CITY OF ALBUQUERQUE

RE: Human Bean Coffee Shop 7301 San Antonio Drive NE Conceptual Grading & Drainage Plan Engineer's Stamp Date: 05/08/23 Hydrology File: E19D025B2

Based upon the information provided in your submittal received 05/12/2023, the Conceptual Grading & Drainage Plan is approved for action by the Development Facilitation Team (DFT) for Site Plan for Building Permit.

> CONCEPTUAL GRADING AND DRAINAGE

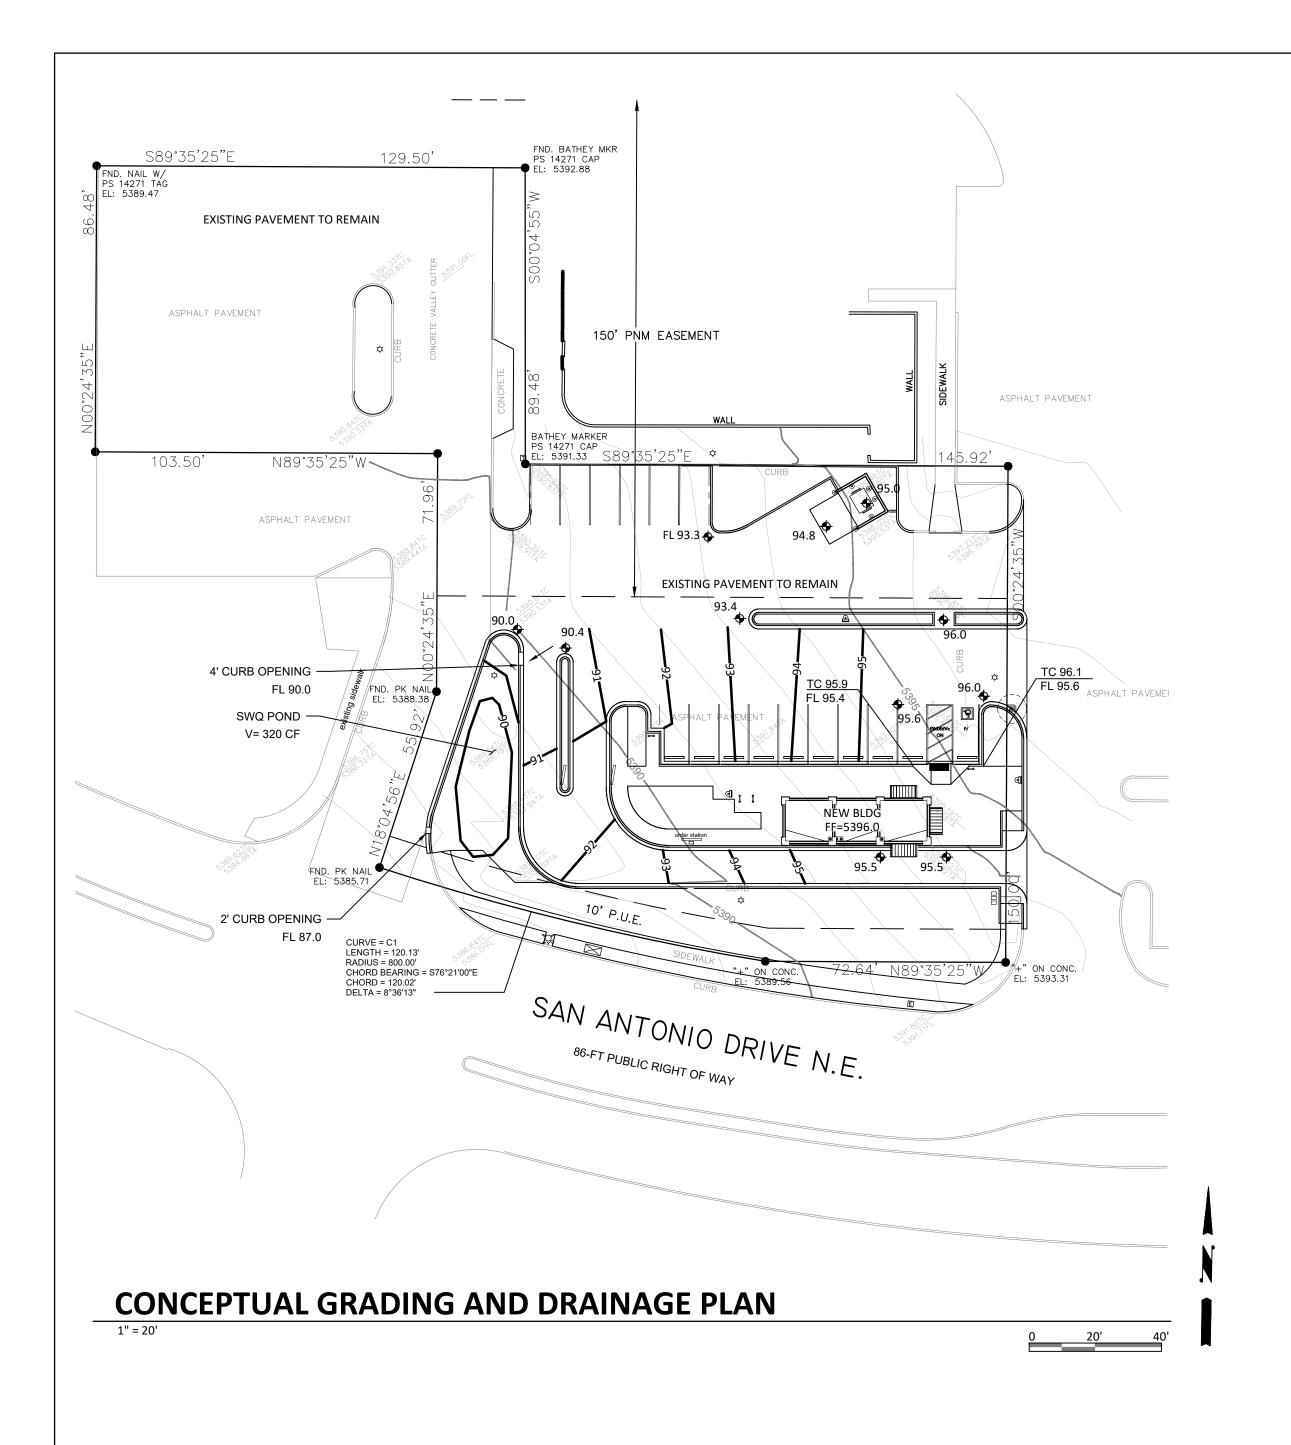
1. Please submit a more detailed Grading & Drainage Plan to Hydrology for review and approval. This digital (.pdf) is emailed to PLNDRS@cabq.gov along with the Drainage Transportation Information Sheet.
